WASHINGTON UTILITIES AND TRANSPORTATION COMMISSION

PETITION TO MODIFY WARNING DEVICES AT A HIGHWAY-RAILROAD GRADE CROSSING

USDOT: 662526C

0313 BARKER - UNION PACIFIC CROSSING
UNION PACIFIC RR CROSSING LAYOUT
BARKER RD / UNION PACIFIC
CROSSING, SPOKANE VALLEY, WA
MP 0012.99, DOT 662526C

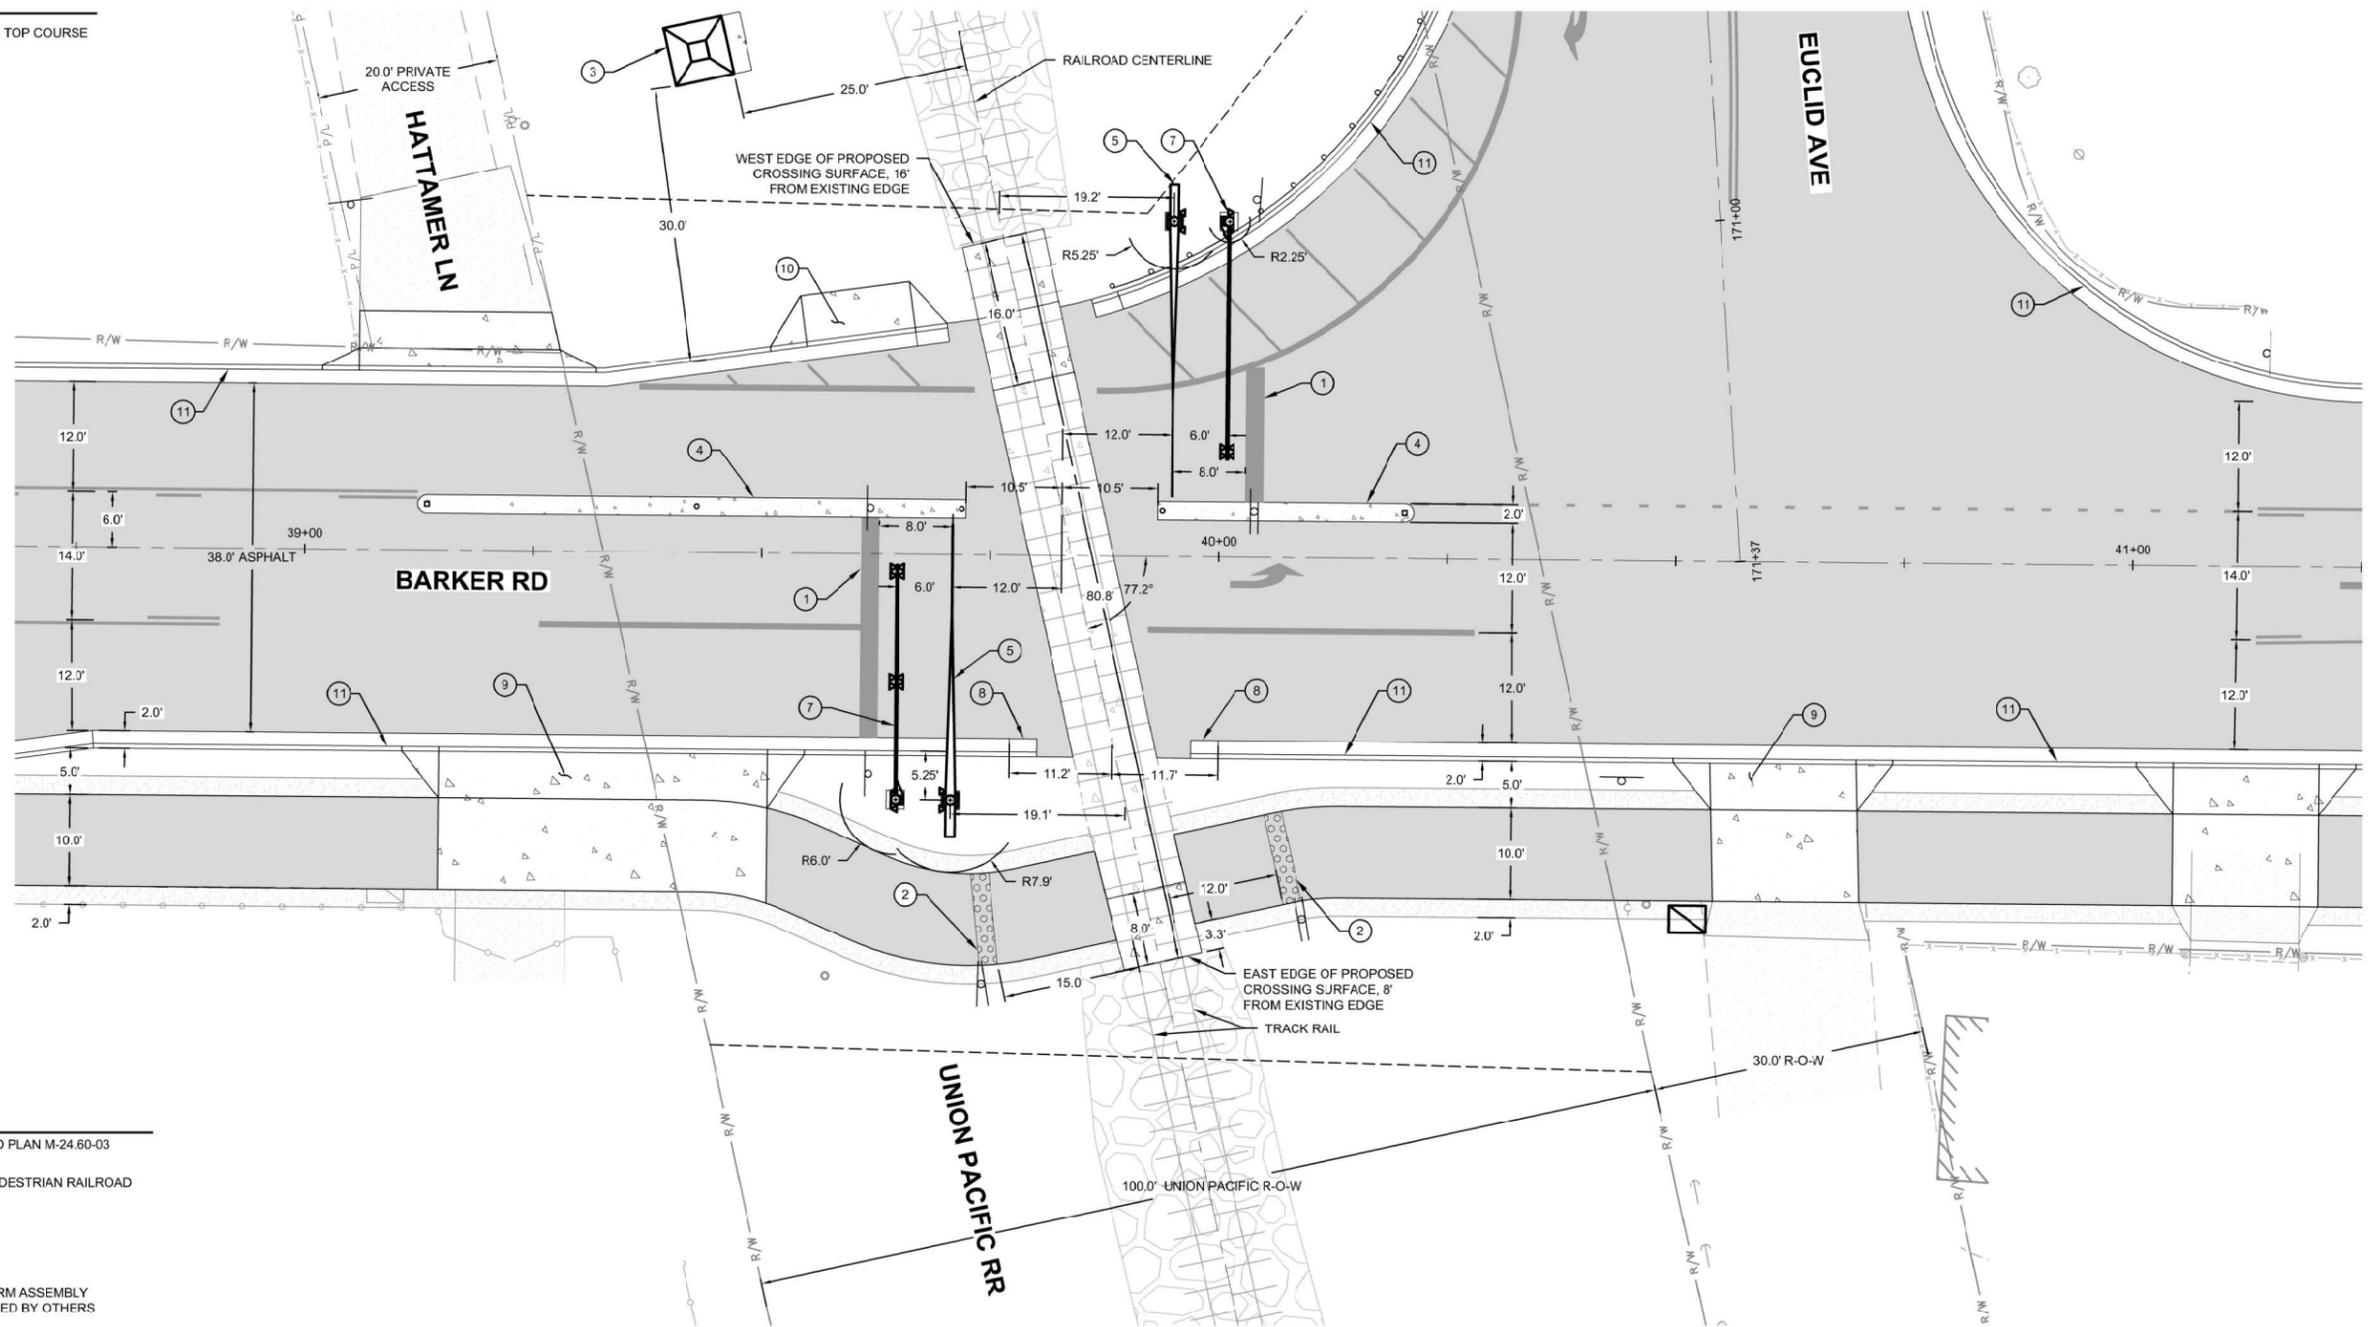
One cantilever, and one quad gate/flasher for each direction of travel. Northbound cantilever provides flasher for both lanes. Southbound cantilever also has 2 sidelights for eastbound Euclid Avenue and westbound access road travel. Two (2) driving lanes northbound, one (1) driving lane southbound and one (1) multi-use path on east side to be maintained by City - Nine (9) flashers and three (3) bells total.

Two stop bars, two W10-1 approach signs, two W10-4 approach signs, two RR Xing pavement markings and other signage in accordance with the MUTCD.

Replace concrete crossing surface with new wider 81ft (10 panels) concrete crossing surface in order to accommodate traffic lanes and multi-use path.
